LAND BOUNDED BY HAVERSTOCK ROAD, WELLESLEY ROAD AND VICAR'S ROAD INCLUDING NOS 121-211 BACTON LOW RISE ESTATE 113A, 115 AND 117 WELLESLEY ROAD AND 2-16 VICAR'S ROAD, NW5 4. S73 APPLICATION TO AMEND EXTANT PERMISSION(S) FOR THE REDEVELOPMENT OF BACTON LOW RISE (PLANNING APPLICATION REF: 2012/6338/P AS AMENDED BY REF 2014/3633/P AND 2015/1189/P).

This letter responds to the London Borough of Camden's (LBCs) transport comments received 15 November 2016 regarding the S73 application (ref: 2016/5358/P) submitted 29 September 2016 to amend conditions; 3 (detailed drawings), 6 (overlooking), 7 (refuse & recycling), 9 (cycle storage), 10 (car parking), 11 (electric vehicle charging points), 12 (car club bay), 13 (motorcycle parking), 23 (wheelchair units), 25 (contaminated land measures), 26 (biodiverse roofs), 27 (bird and bat details), 28 (lighting strategy), 29 (landscaping details), 32 (building foundations), 34 (drainage details), 36 (CCTV strategy), 37 (car club parking), 40 (re-appraisal of financial viability), 43 (energy efficiency), 44 (code for sustainable homes), 45 (car free), 47 (construction management plan) and 58 and 59 (approved plans), of planning permission 2012/6338/P

Figure 4.2 Proposed Cycle Parking Locations

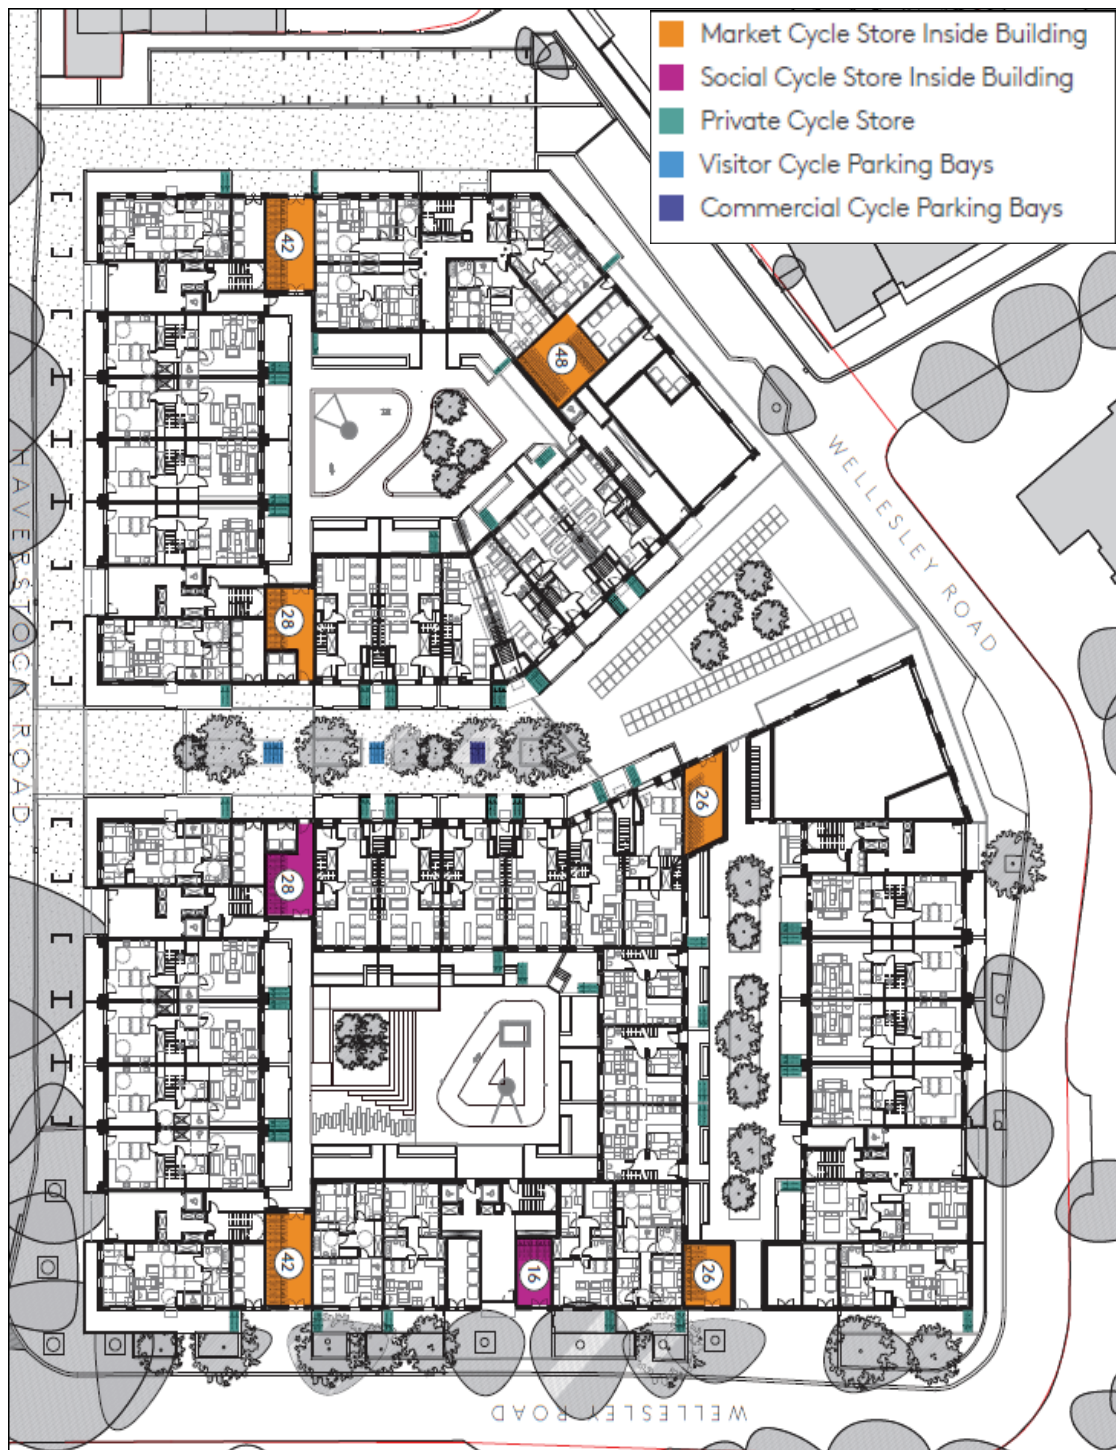
The LBC Transport comments sent 15 November 2016 ask for detail of "*the number of spaces being provided for each location, how these match the number and mix of units they are serving and how they correspond to the London Plan*". The S73 application relates principally to the BLR site, proposes its delivery as a single

Figure 4.2 (Proposed Cycle Parking Locations) of the Transport Statement submitted in support of the S73 application (ref: 2016/5358/P), at Appendix 2 of this letter, illustrates the location of the proposed cycle storage spaces “*off-street within the boundary of the site*” (CPG 7), in accessible and secure locations across the BLR site. Appendix 2 also indicates the number of cycle storage spaces provided at each of the cycle stores across phase 2.
